TECHNICAL COMMITTEE MEMORANDUM TCM 10/04

DMM Ascent helmet, Head injury

Incident Ref. 08/10/F.KIN

Fig 1. Internal rivet location

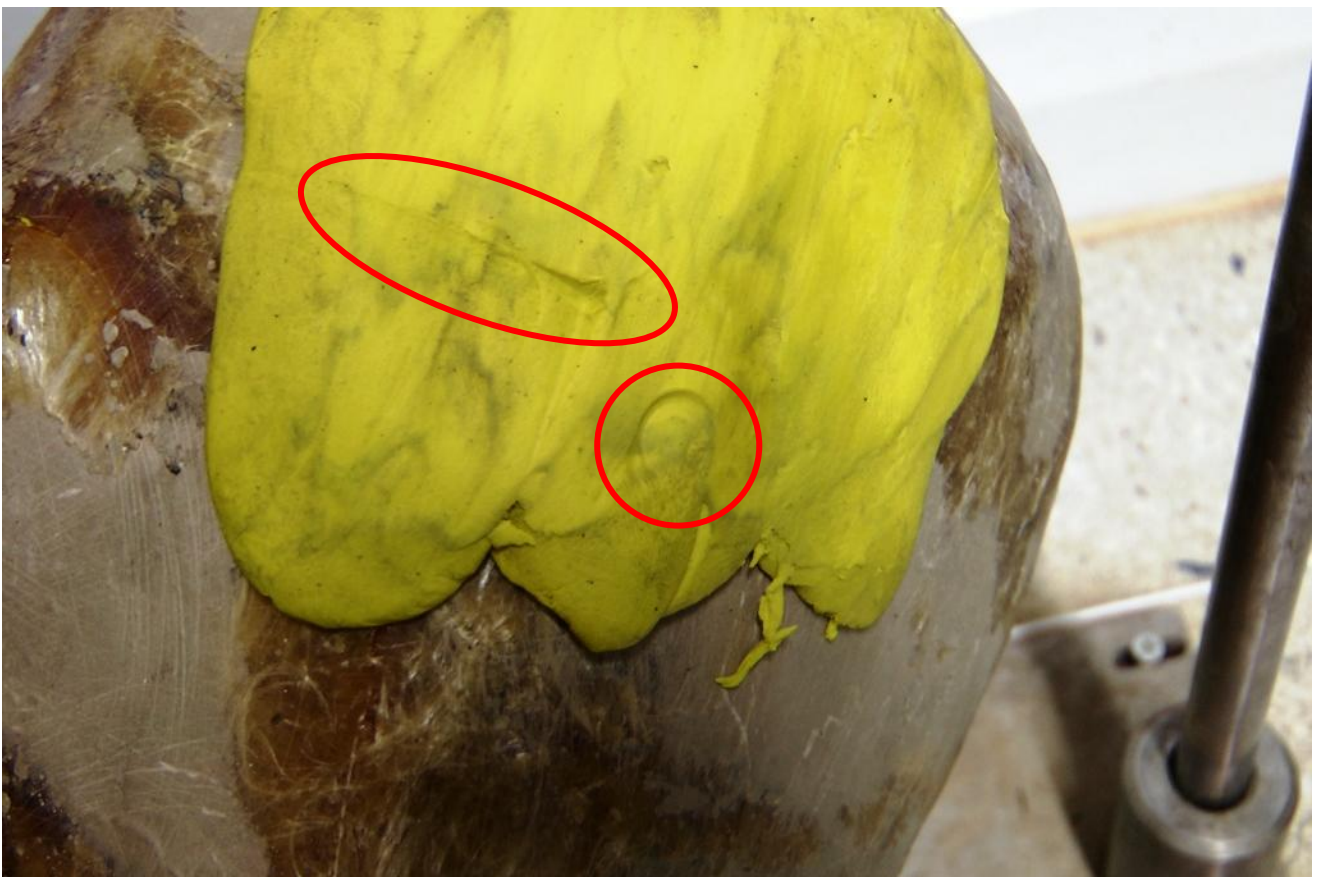
The helmet is of hybrid construction, consisting of a relatively stiff plastic shell and an expanded foam liner. Four identical plastic mouldings act as headlamp clips on the exterior of the shell, each secured on the inside of the shell with two attachment points. These attachment points are additionally used to secure both an interior adjustable head cradle, and the chinstrap system. A photo of their location was taken. [Fig 1]

Examination of the 8 attachment points found that they have a small and almost hemispherical profile protruding into the interior of the helmet. To protect the head, four of the attachment points are covered by a layer of plastic backed foam which forms part of the interior cradle. The remaining four points have a semicircle of soft foam padding surrounding them.

The big surprise here was that there were no noticeable indentations left by the 8 obvious rivets. Further inspection gave a possible explanation for this. The four highest rivets are located close to the edge of the foam liner. Unless this liner is significantly compressed, then these rivets are unlikely to contact the head. The four lowest rivets are covered by a plastic sheet and soft foam. Whilst it seems logical to assume that under a major impact that this soft foam might compress and allow

Whilst the degree of protection to be expected from impacts in this area is therefore very limited, the wisdom of allowing obvious protusions such as the exposed rivets to be present inside the helmet must be questioned. A limitation of the EN12492 standard is that not all areas are impact tested, and many helmet designs have protusions of the shell or parts of the cradle/retention system which could contact the head during impacts.

However as part of our ISO9001:2008 registered Quality Management System we are constantly reviewing our product range with a view to making improvements to the product and as a result of investigation into this incident we are proposing making a modification to our helmets which will help prevent the type of injury sustained happening again. The manufacturer is investigating alternative methods to attach the cradle and straps to the helmet and expects to ship us a modified prototype early next week.
